West Midlands Interchange Proposed Non-Material Change Environmental Implications Report

West Midlands Rail Freight Interchange Order 2020 (as amended).

Four Ashes Limited
June 2023

Figure 3.5: Proposed Canal Feeder Channel Diversion

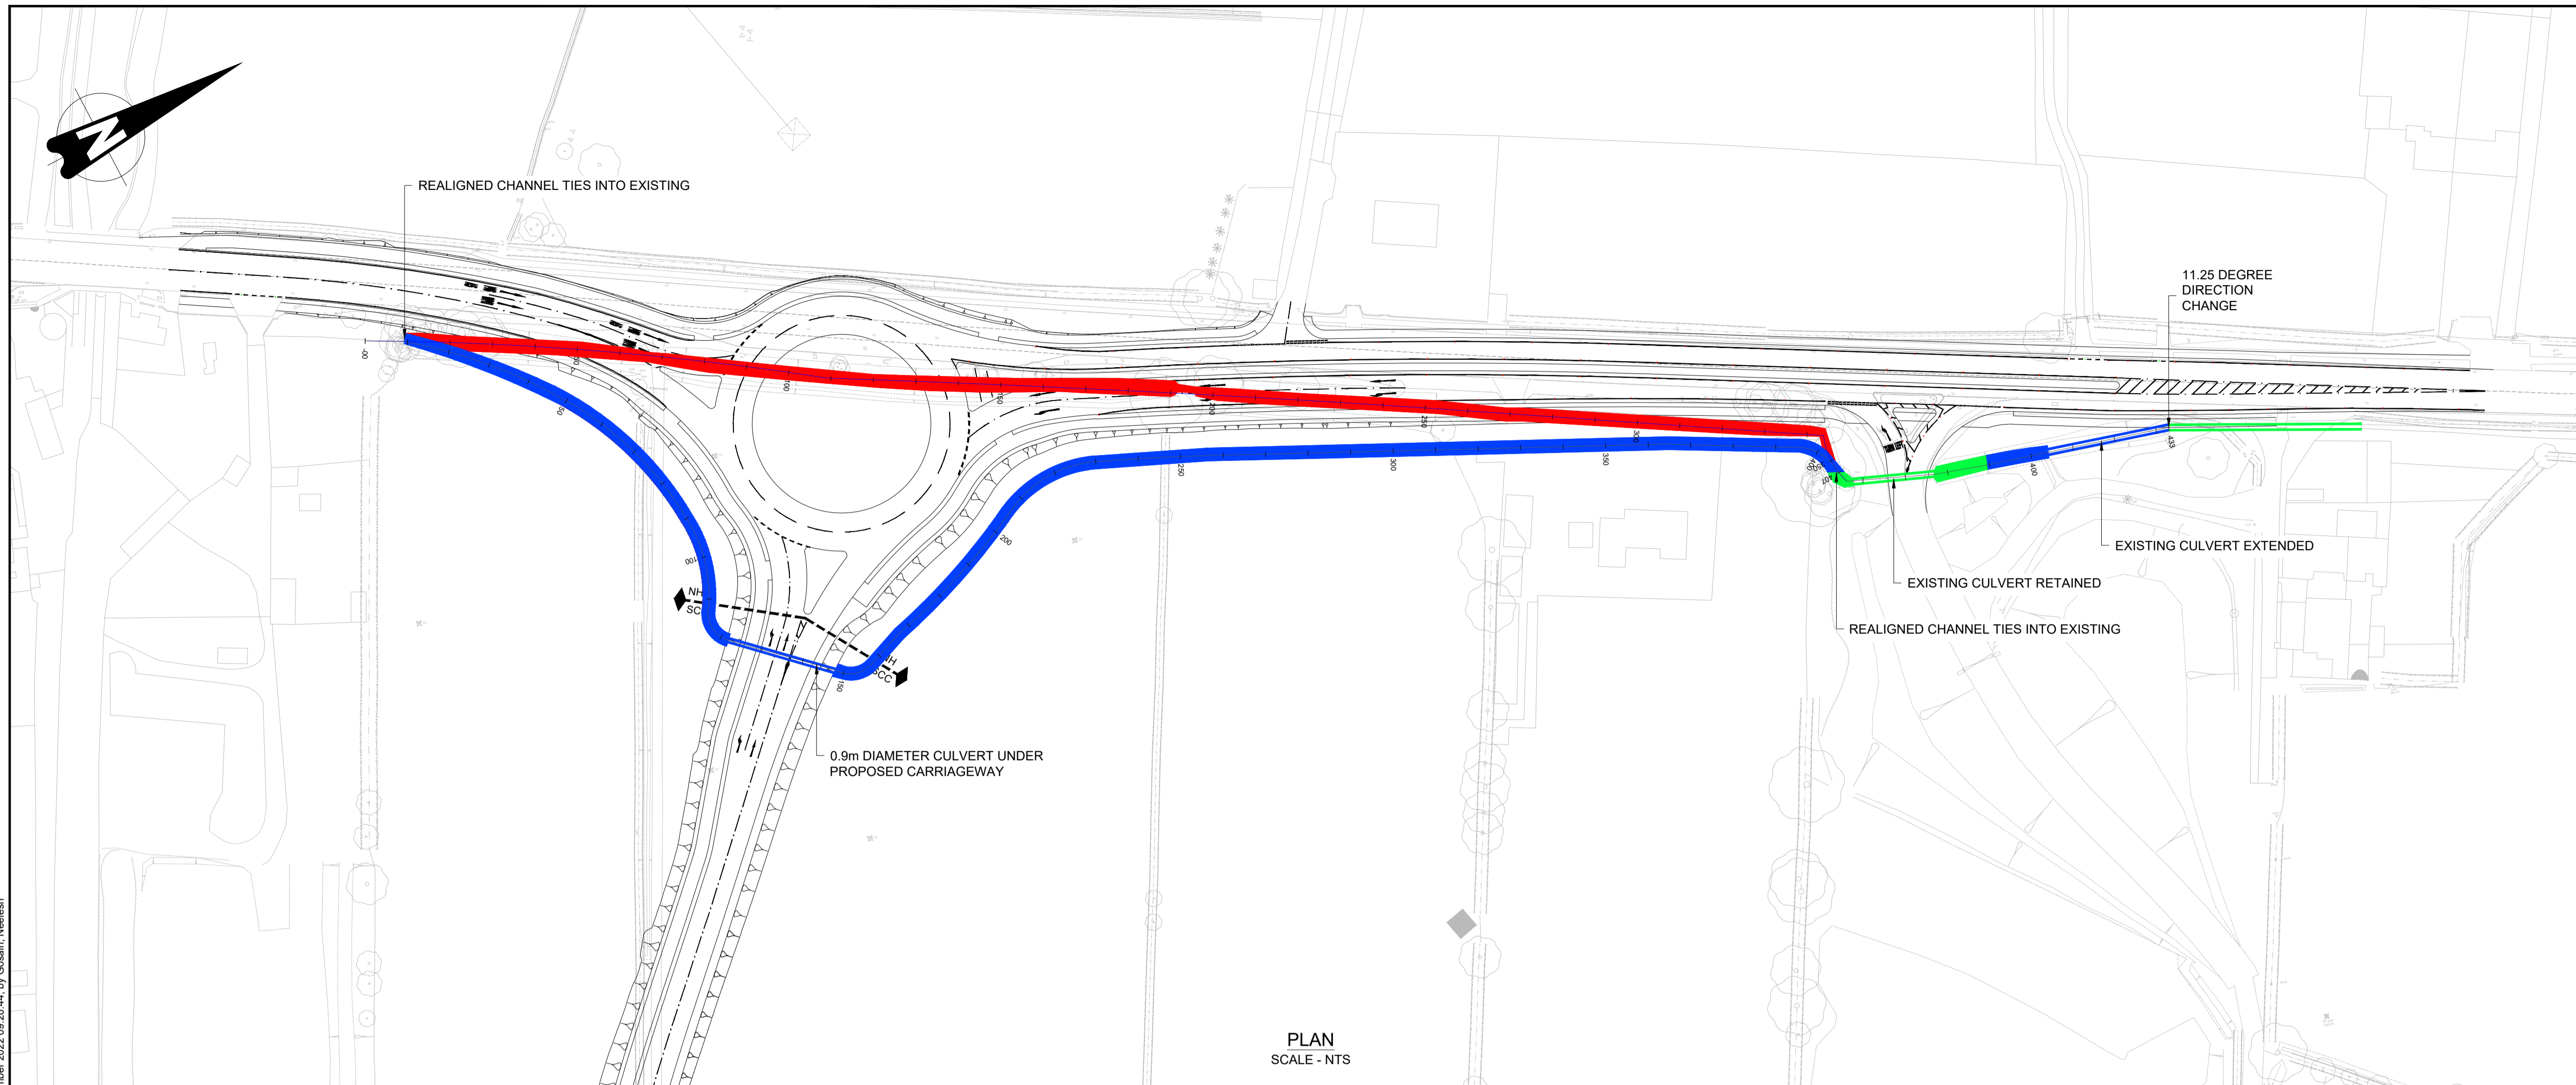
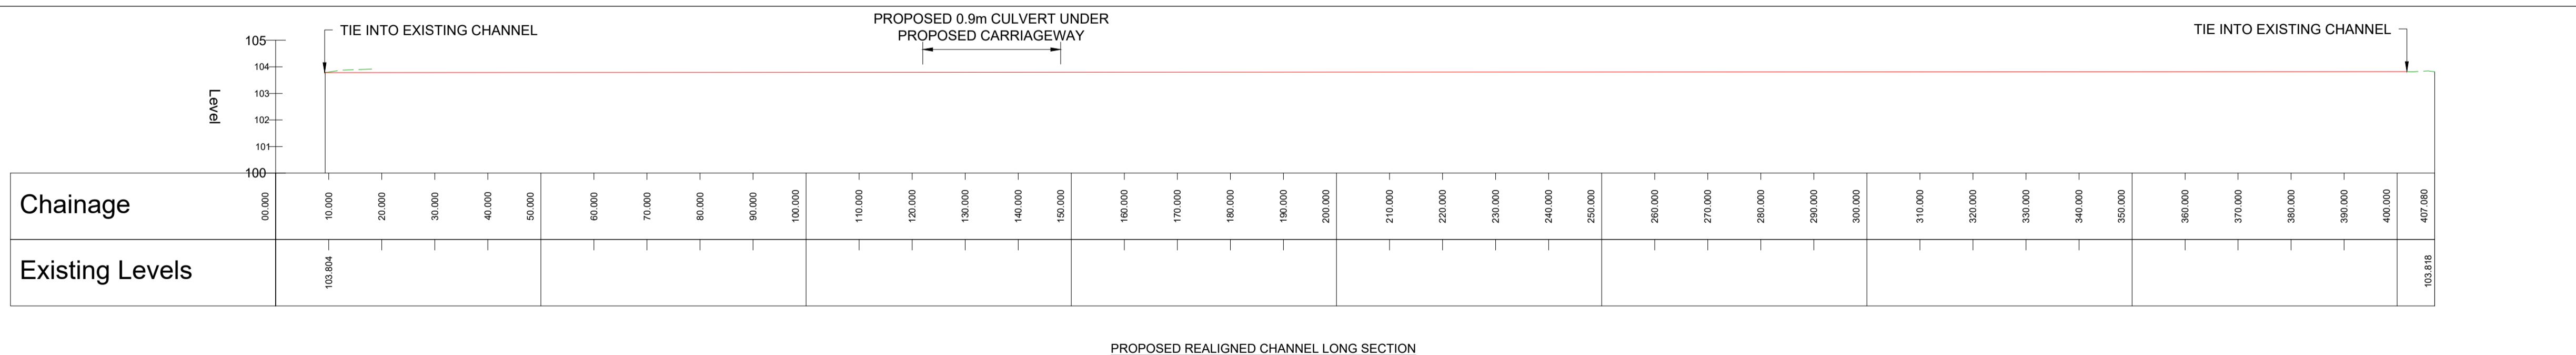
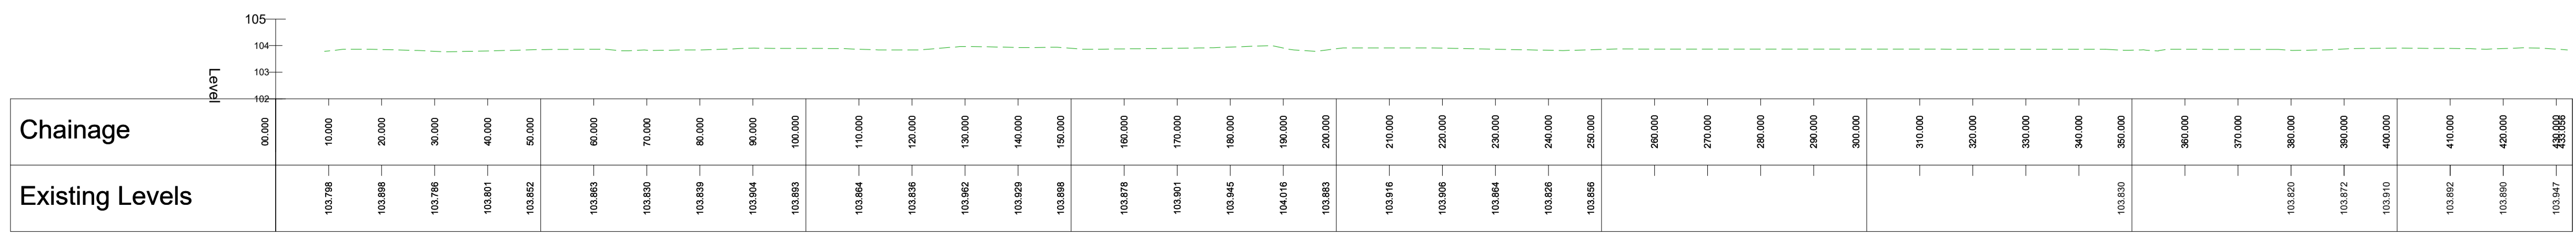
- +104.5m AOD to +105.7m AOD in order to accommodate a culvert underneath the proposed A5/A449 Link Road connecting the Calf Heath Reservoir with the Staffordshire and Worcestershire Canal (**Figure 3.5, Appendix A**);

Figure 3.6: Proposed Development Zone Parameter Plan - Zone C Southern Extent

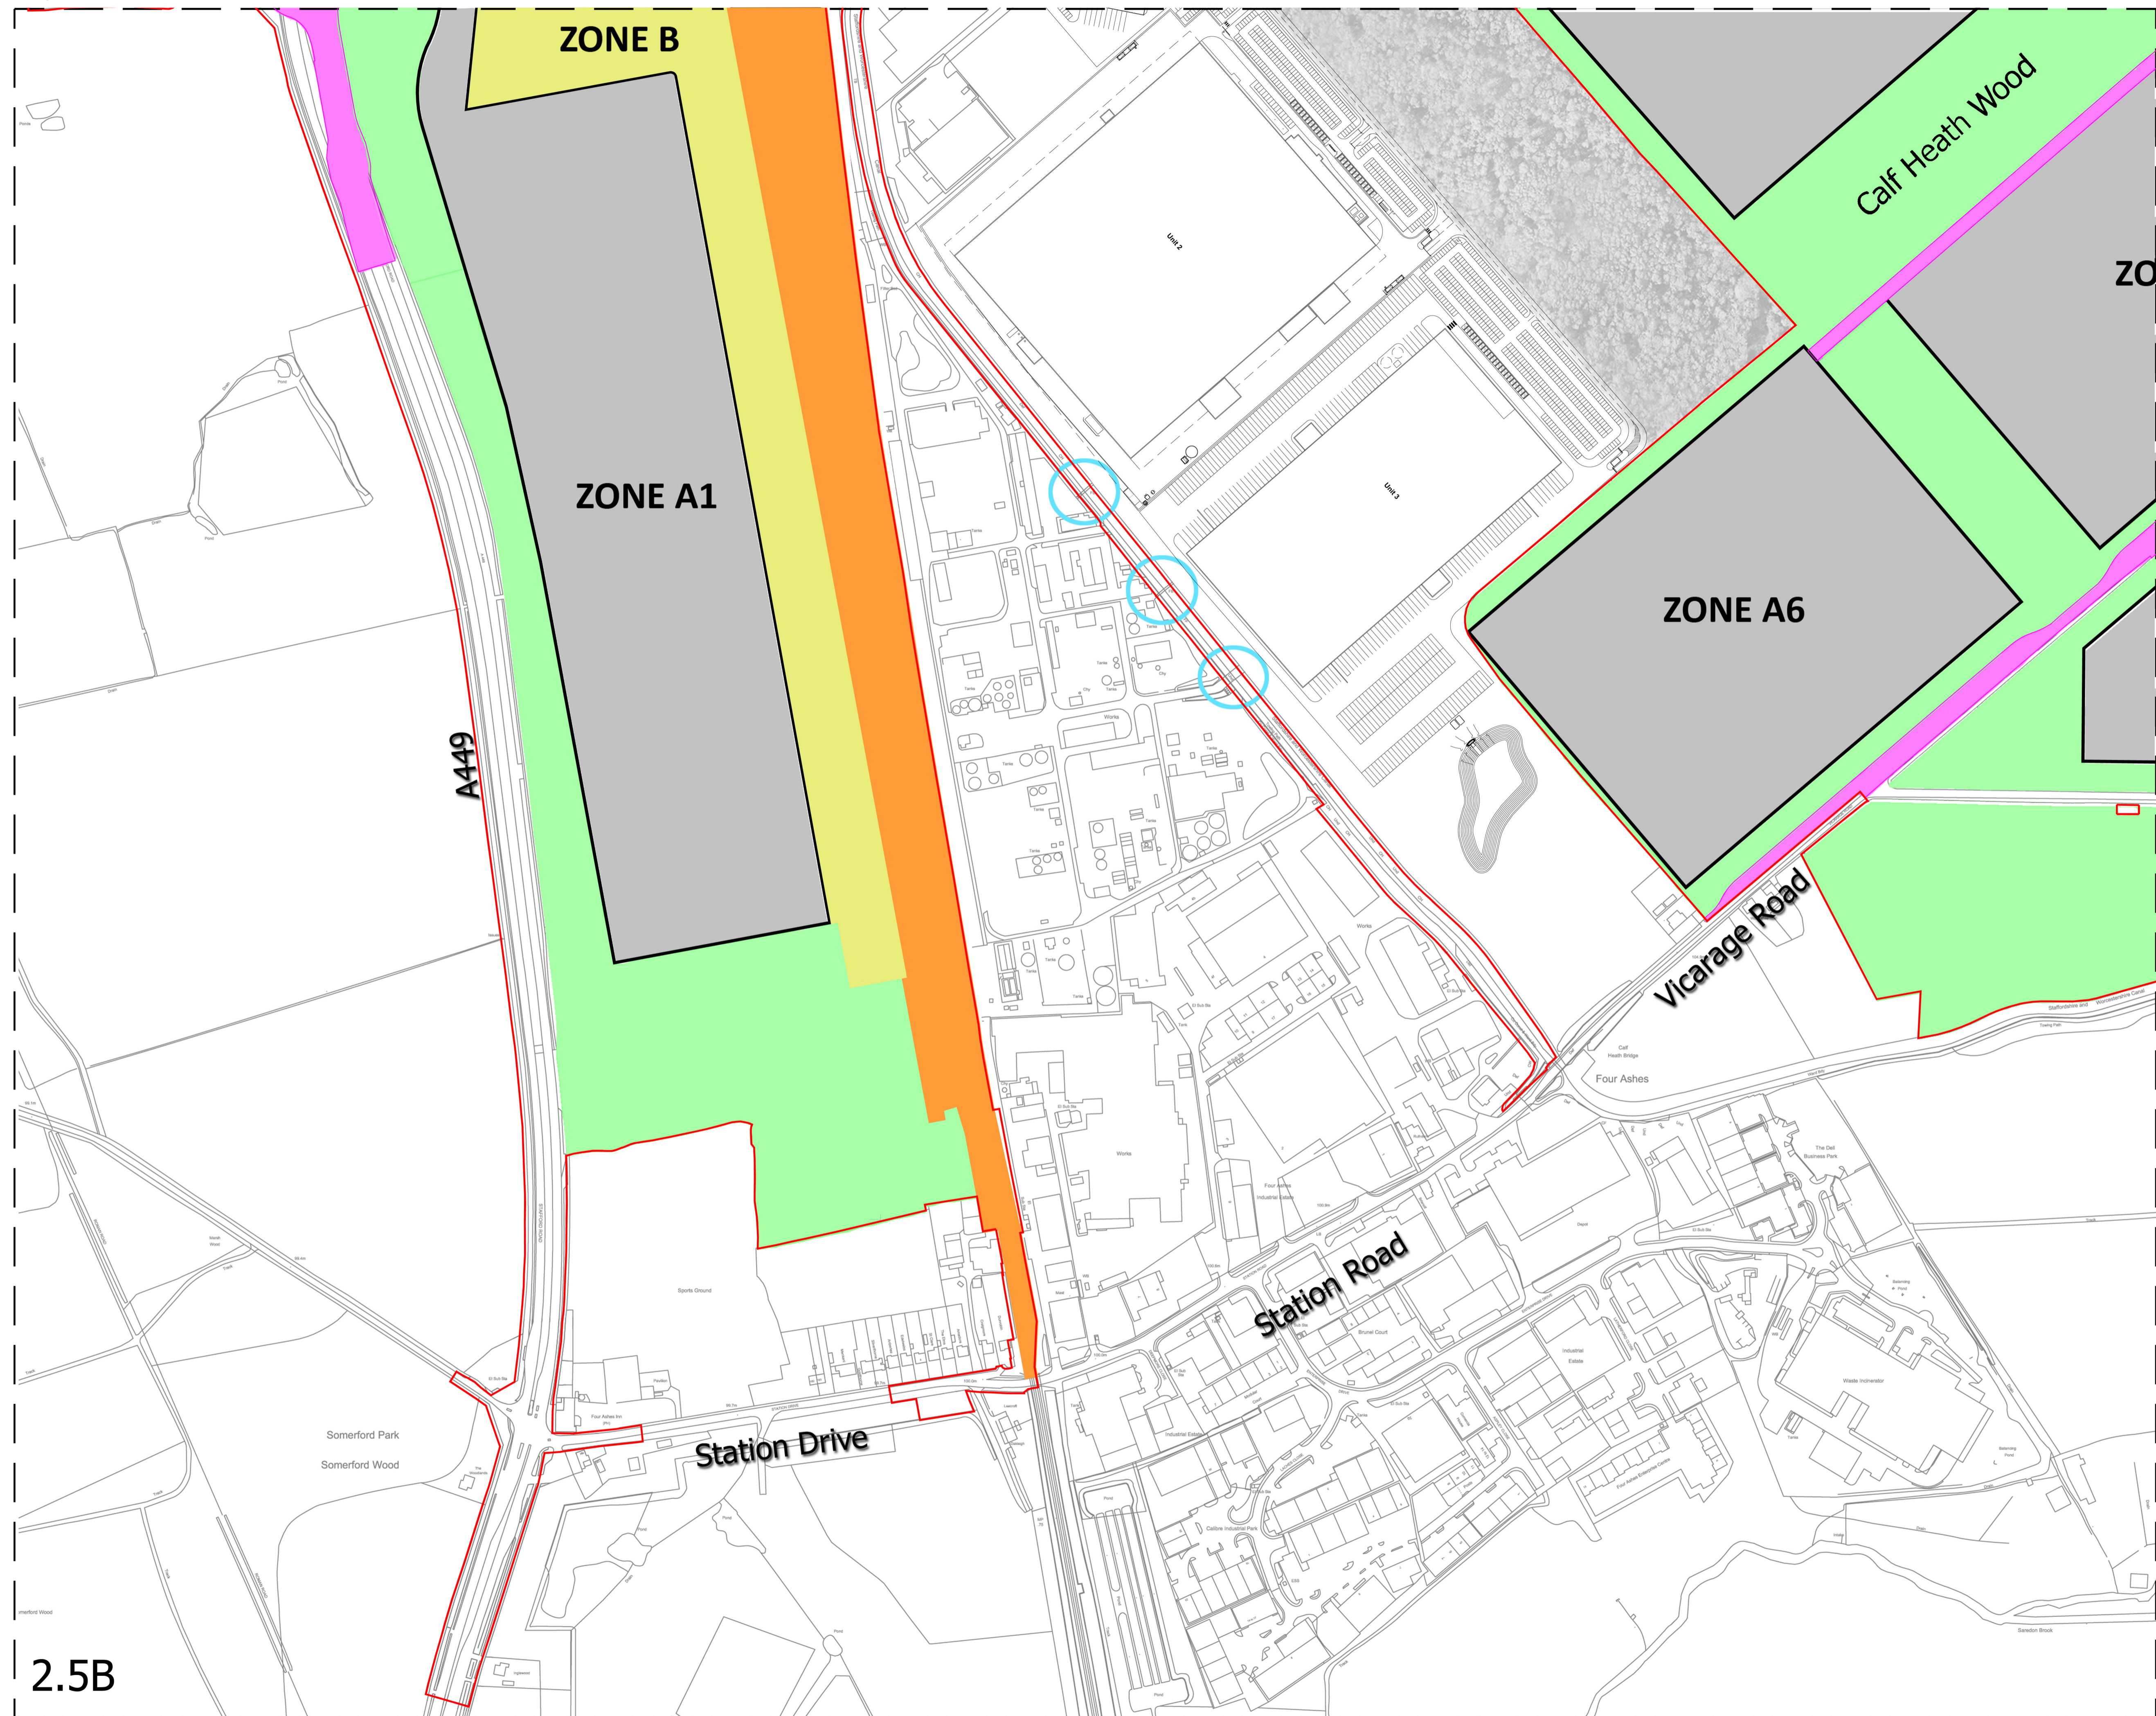
As shown in **Figure 3.6, Appendix A**, the proposed amendment seeks to incorporate additional land into Zone C (railway works), comprising 0.2797 ha, to accommodate the extension of the proposed tracks running up to the two buffer stops (The Cripple Siding Buffer Stop and the Neck Shunt Trap Buffer Stop). This would result in a net reduction in area identified as Landscaping land on the certified Development Zone and Green Infrastructure Parameters Plan by 0.2489 ha, together with expanding the Zone C extent and associated Order Limits boundary southwards to include 0.0308 ha of land at Craigmere, which is owned by FAL.
